# Proposed amendment to GCU APPENDIX 9

Title:	Amendment of codes 1.4.1 and 1.4.2 in accordance with EN-15313 2016	
Proposed amendment made by: RU / keeper / other body	Prepared by DB Cargo AG/SBB Cargo AG	
Proposed amendment concerns:	Appendix 9	
Proposer:	Jean-Marc Blondé	
Location, date:	Olten, 20/01/2020	
Concise description:	A limit of 36.0 mm is specified in the provisions of the GCU for the height of the wheel flange. A limit of 27.5 to 32.0 mm is specified in the Usage Guidelines for Composite Brake Blocks (tenth edition) applicable to the use of LL brake blocks on freight wagons with a maximum speed greater than 100 km/h.  Verification of maximum thickness of flanges is introduced for LL and K disc braked vehicles.

A2020-02 25/06/2020 1/6

#### Additional text and/or change relates only to proposed amendments to GCU 3. Appendix 9:

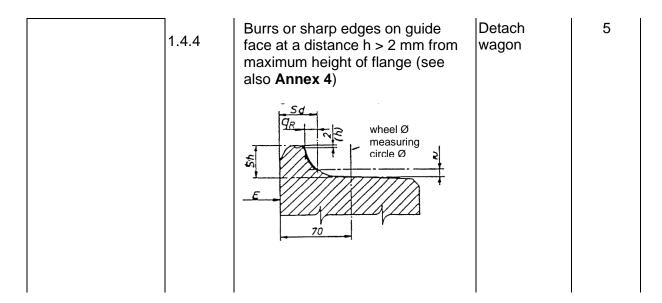
Component	nponent Code Irregularities/Criteria/Notes no.		Action to be taken	Irregu- larity class	
Flange	1.4				
	1.4.1	Height of flange S <sub>h</sub> greater than 36 mm • hollow on wheel tread	Detach wagon	4	
		Wagon with LL brake blocks and permissible speed greater than 100 km/h			
		Height of wheel flange S <sub>h</sub> greater than 32 mm • Hollow on wheel tread			
	1.4.2	Flange thickness S <sub>d</sub>	Detach	5	
		- wheel ∅ > 840 mm S <sub>d</sub> < 22 mm	wagon		
		- wheel Ø: <del>630 (330) mm</del> 760 mm <≤ d ≤ 840 mm, S <sub>d</sub> < <del>27.5</del> <del>25</del> mm			
		- wheel ∅ ≤ 760 mm, S <sub>d</sub> < 27.5 mm			
		<ul> <li>wheel Ø &gt; 330 mm on wagons with LL or K brake blocks S<sub>d</sub> &gt; 33 mm</li> </ul>			
		<ul> <li>worn flange</li> </ul>			
	1.4.3	Wear of guide faces	Detach wagon	5	
		<ul><li> qR ≤ 6.5 mm (see Annex 4)</li><li> sharp flange</li></ul>
